Burlington Design Advisory Board

ZP-24-276; 206-208 Dale Road (RL, Ward 4) Wild Dale, LLC / Matt Brouillard
Proposed construction of a new duplex on existing vacant lot created under ZP-24-159. (Project Manager, Mary O’Neil)

MEMORANDUM

To: The Design Advisory Board
From: Mary O'Neil, AICP, Principal Planner
RE: ZP-24-276
Location: 206-208 Dale Road
Date: July 23, 2024

T.O. DECK
@ 99'-6"

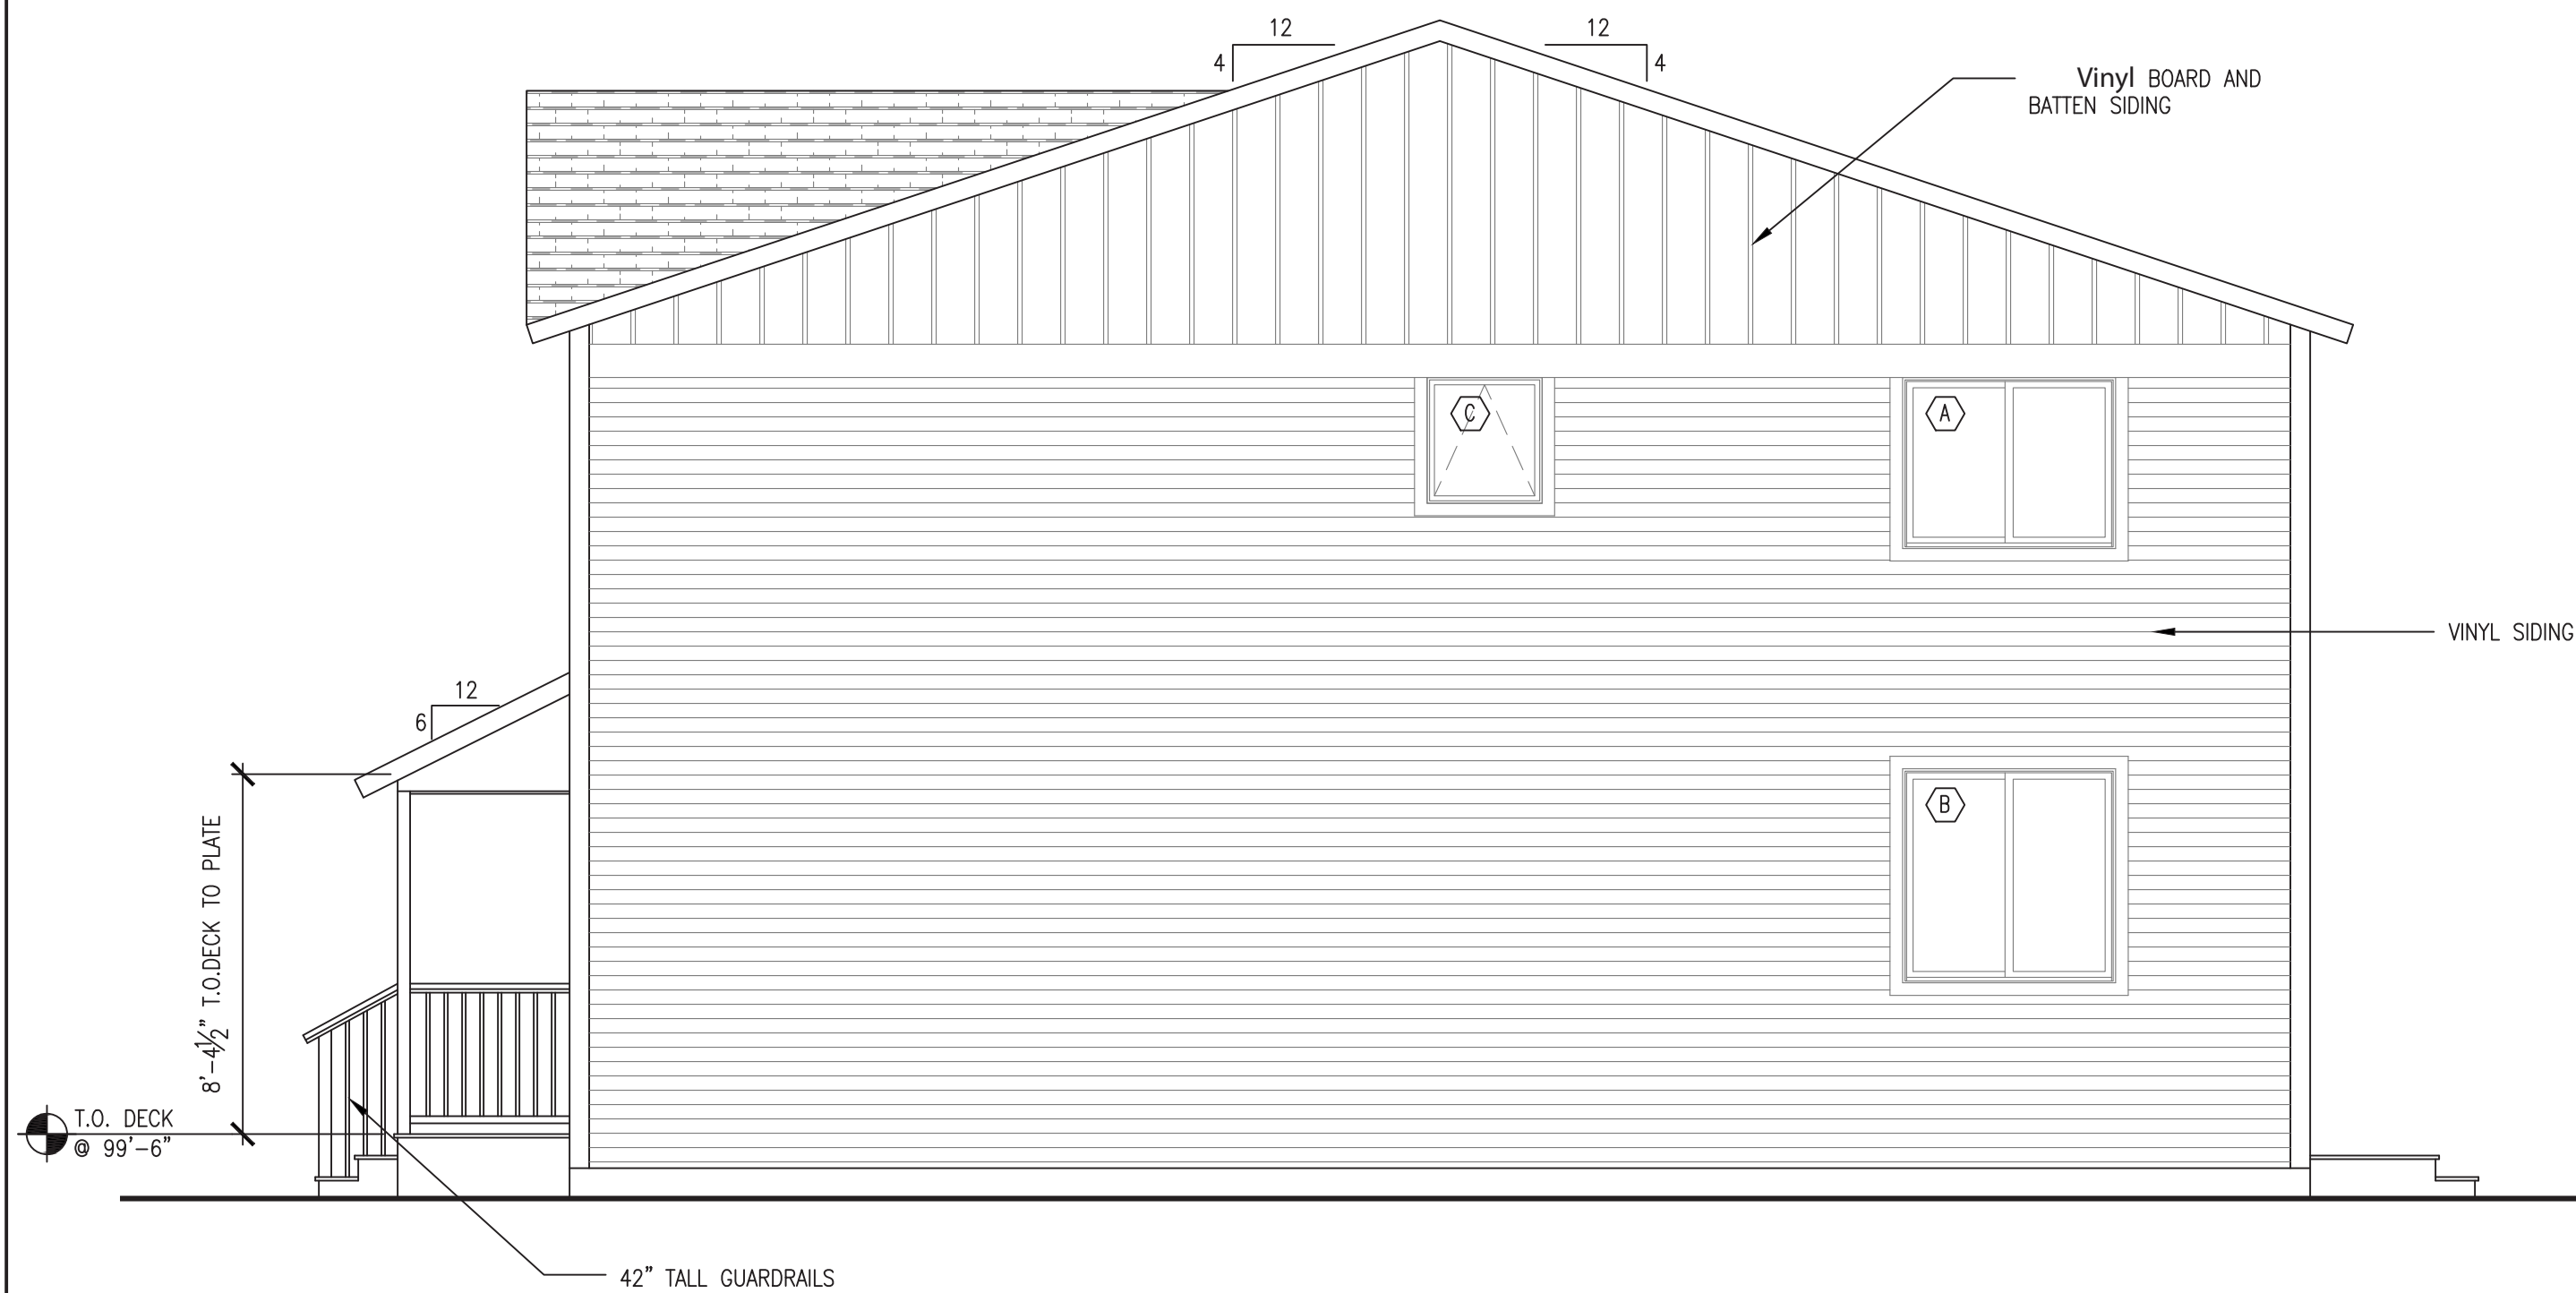
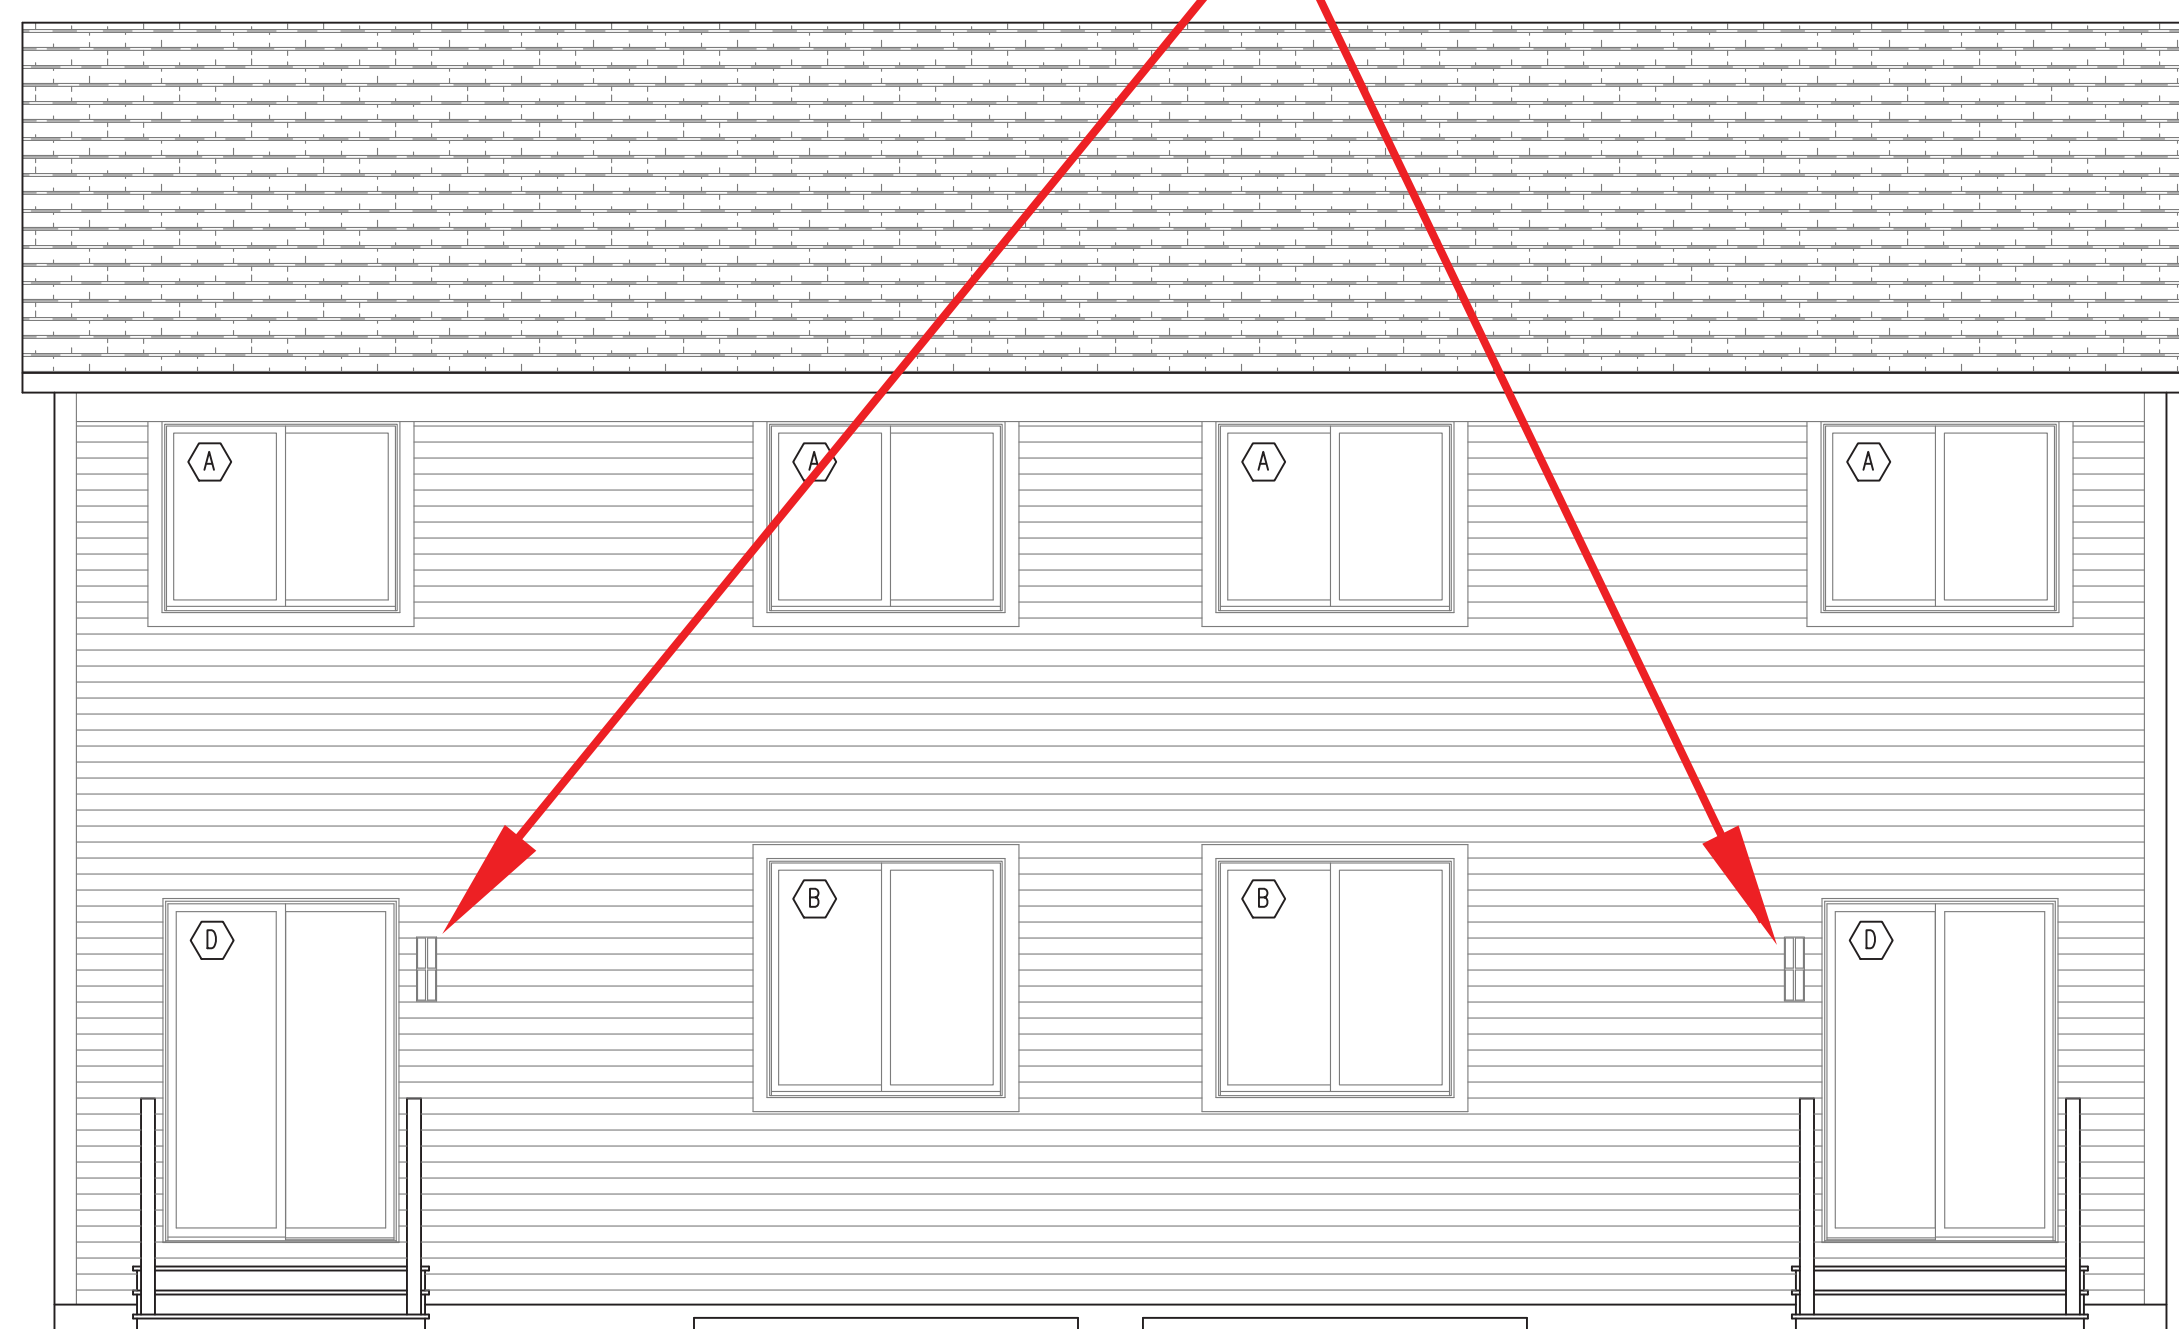
Condensing units are illustrated at the northwest (side) elevation. Mailboxes are adjacent to front entrances. Trash and recycling will be located within the garages. Utility meters are located on a side (northwest) elevation. Reference is made to Plan A2.1.

There remain large expanses of blank walls on the north and south elevations that could improve the livability of the units and provide additional interior daylighting if more windows were included. To successfully achieve these goals, a revised floor plan is recommended, placing interior stairs along interior party walls rather than along exterior walls.

Windows have been symmetrically placed across all elevations. The deficiency in the plan is the dearth of windows on north and south elevations, resulting from the proposal to arrange interior stairs along exterior walls. (This was a similar weakness

Plan A2.1 defines the intention of asphalt shingle roofing, composite board and batten in the gable ends and vinyl siding for the bulk of the structure. All are considered acceptable for new construction.

6. A revised floor plan is strongly recommended; placing interior stairs along party walls to accommodate more windows along northwest and southeast elevations. Revisions will allow for expanded opportunities for daylight into interior rooms, increased air circulation, and an improved floor plan allowing greater resident enjoyment.
